CITY OF
**PALO
ALTO**

Architectural Review Board Staff Report

Study Session to provide feedback on the Pre-Approved Parklet Designs and the Associated Draft User Guide.

Figure 1: Setback from Rear-edge of angled parking space

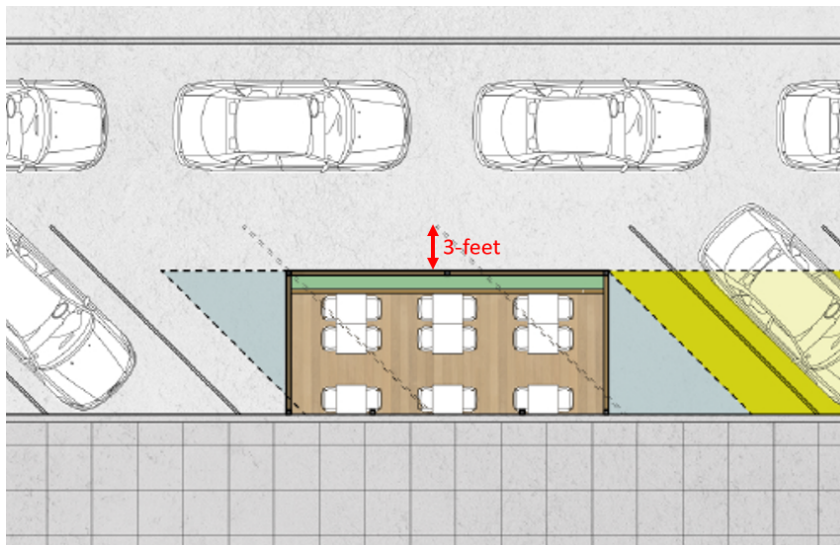
Board members and the ARB ad hoc committee suggested reducing the required 3-foot setback from the rear-edge of an angled parking space (see Figure 1 below) to 2-feet, which is consistent with the setback requirement for parklets in parallel parking spaces.

Staff recommends maintaining the 3-foot setback to preserve the vehicle sight distance from adjacent driveways and alleys. Parklets in angled spaces are much deeper than parklets in parallel spaces and they extend further into the travel lane.
